Compressor Replacement Kit for CSHB to CSHC Conversion, KIT08393

Models: CSHC, CSHB, TTA090A

Compressor replacement illustration for TTA090A

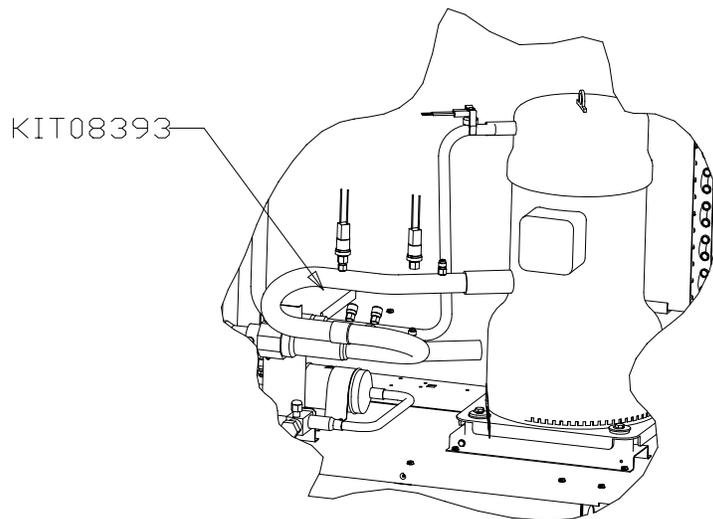
1 - Suction tube assembly, part number D670710G01

1. Remove compressor by following compressor service guidelines.
2. Remove current suction tube from compressor.
3. Replace compressor and braze new tube(s) into new compressor.
 - It is important that a dry nitrogen purge is used while brazing.
 - Make sure not to overheat service valve. Use a wet rag to cool parts while brazing.
 - Add suction line filter when necessary.
